# UNITED STATES PATENT AND TRADEMARK OFFICE

APPLICATION NO.	FILING DATE	FIRST NAMED INVENTOR	ATTORNEY DOCKET NO.	CONFIRMATION NO.
10/547,191	06/28/2006	Guntram Scheible	0070996-000044	9175

<b>Office Action Summary</b>	<b>Application No.</b> 10/547,191	<b>Applicant(s)</b> SCHEIBLE ET AL.	
	<b>Examiner</b> KOURTNEY R. SALZMAN	<b>Art Unit</b> 1795

## **DETAILED ACTION**

FIGURE 12 of BOCKO et al.

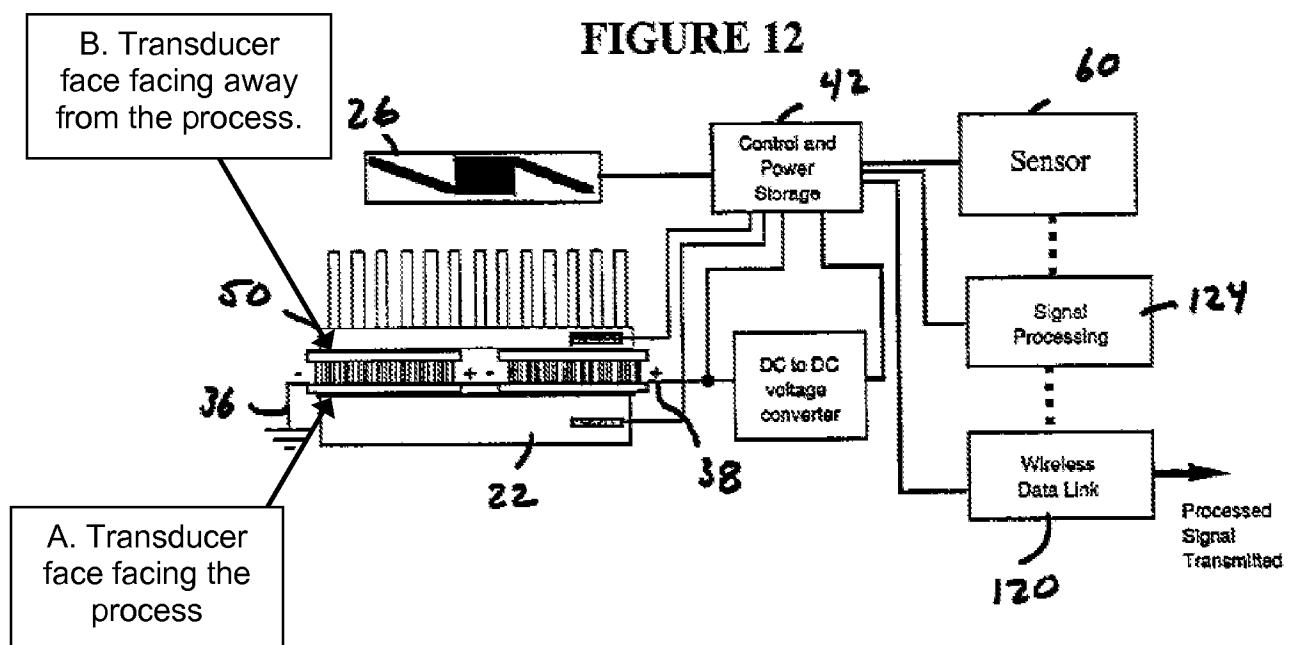
BOCKO et al teaches a field device comprising a housing (limitations a and d of claim 1 of BOCKO et al), process media to create heat in base 22, and wireless data link 120 of figure 12. Figure 12 of BOCKO et al is shown below to identify the transducer faces facing away and toward the process.

As noted in the figure above, face A of the transducer faces the process while face B of the transducer faces away from the process. All sides other than face A of the transducer are situated facing away from the process. For example, the

fan (26), control and power storage (42), sensor (60), signal processing (124) and wireless data link (120) are all situated facing away from the process while the base (22) and face A of the transducer are all situated facing the process.

Regarding claims 2 and 7, while figure 12 shows a hot and cold side discretely, it is through the design of the module that these sides are determined, not that the structure of the thermoelectric converter prevents a different hot and cold orientation. Therefore, it is inherently possible for the thermoelectric converter to function in either directional heat flow, as the structure for both operations is equivalent.

Regarding claims 3, 4, 8 and 11, BOCKO et al shows, in figure 12, for the fins on side 50 to function as a radiator or heat sink, in paragraph 54. Claim 1 of BOCKO et al also describes all the pieces as being inside the housing.
